[Docket No. 97-SW-42-AD; Amendment 39-11092; AD 99-07-07]

Airworthiness Directives; Eurocopter France Model SA 330J Helicopters

ACTION: Final rule; request for comments.

FIGURE 1

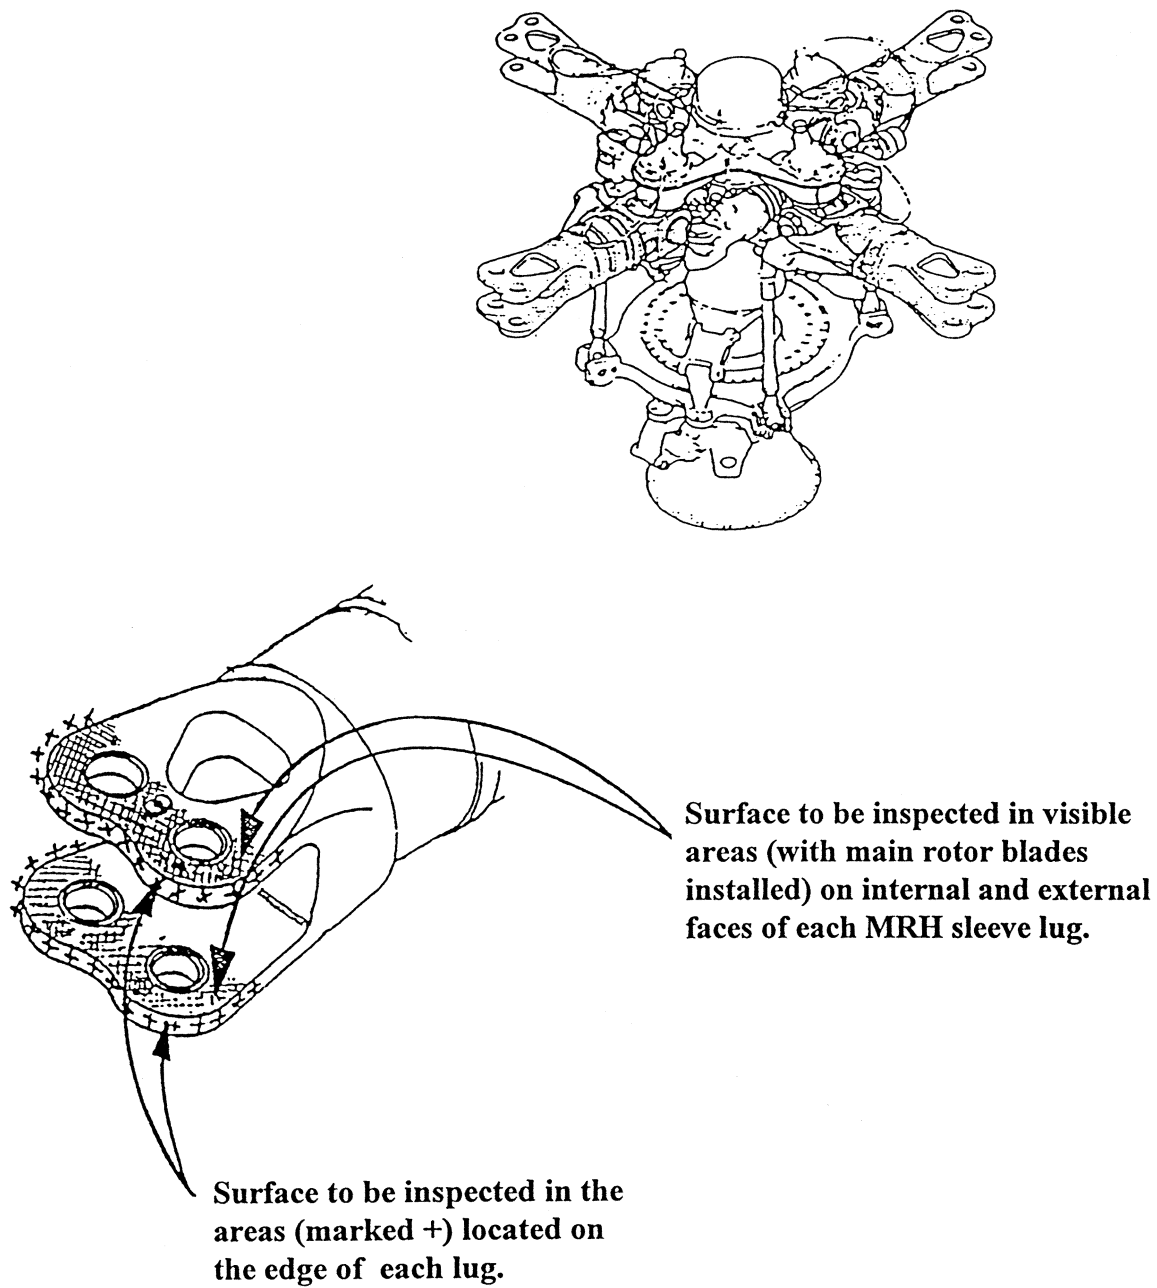
(a) Visually inspect each main rotor head sleeve lug (lug), without removing the main rotor blades, for cracks in the area indicated in Figure 1.

(b) If any crack is found in a lug, prior to further flight, replace the affected sleeve with an airworthy sleeve.
